ENGINE – PROVIDE A NEW LP COMPRESSOR FRONT CASE ASSEMBLY AND A NEW LPC INLET GUIDE VANE ASSEMBLY – CATEGORY CODE 7 – MOD.ENG-72-0018

V2500-ENG-72-0018

Location of the LP Compressor Inlet Guide Vane Assembly and the LP Compressor Front Case assembly
Fig.1

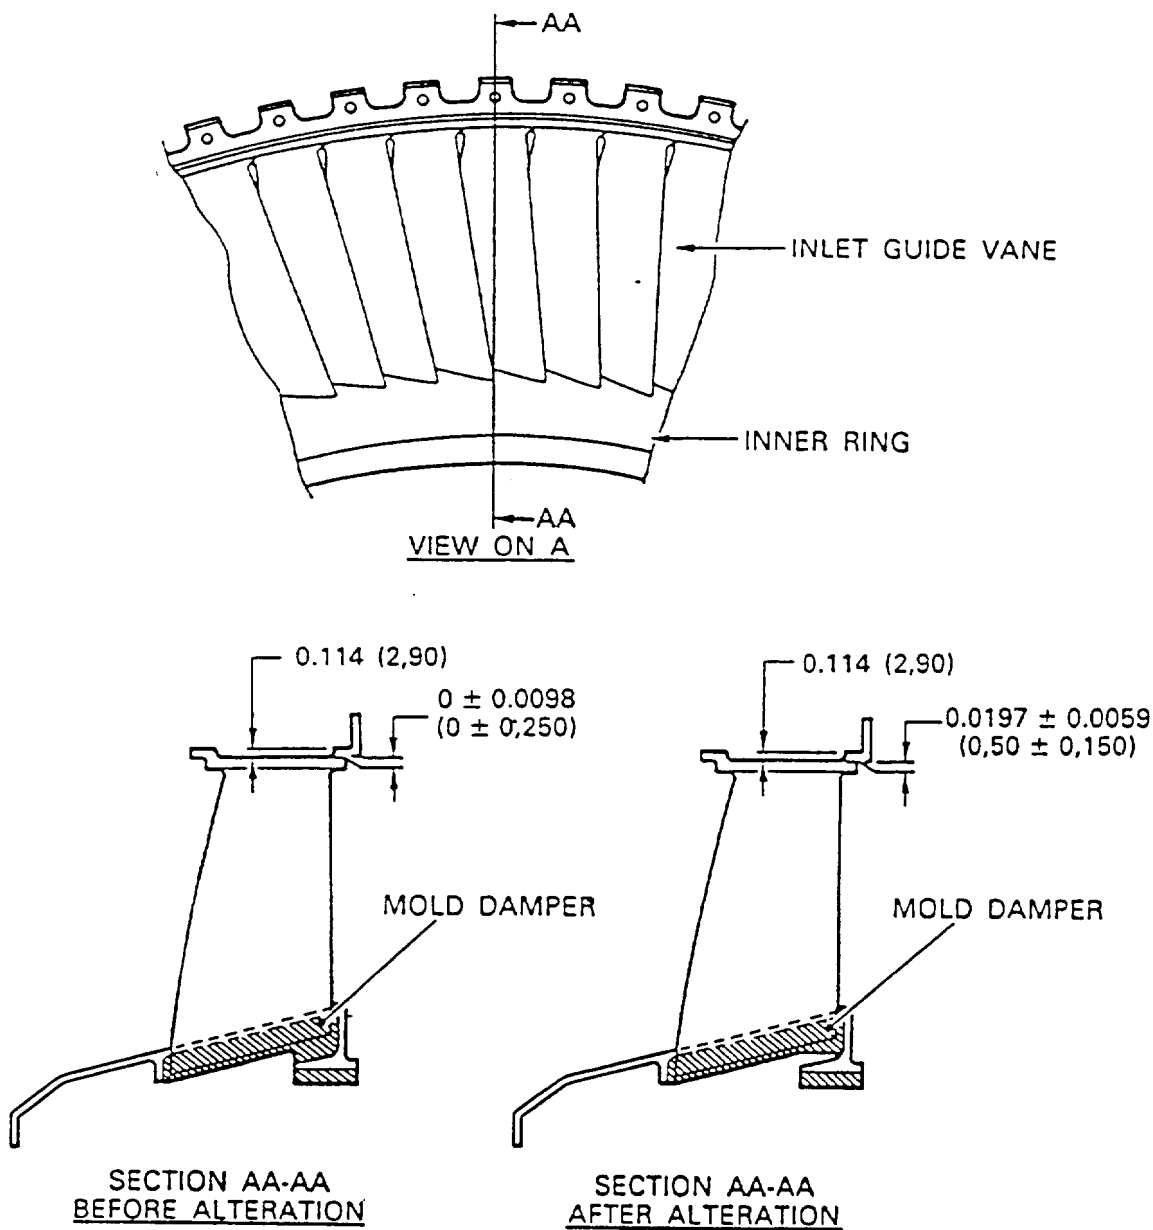
- (1) New LP Compressor Front Case Assemble and new LP Compressor Inlet Guide Vane Assembly which have the following changes have been introduced:
 - (a) The rear flange thickness of the LP Compressor Front Case Assembly has been reduced. (See Figures 1 and 3).

- (b) The thickness of the LPC Inlet Guide Vane platform has been reduced. (See Figures 1 and 2).
 - (c) The molding shape of the damper rubber in the LPC Inlet Guide Vane inner ring has been changed to reduce a quantity of the damper rubber. (See Figures 1 and 2).
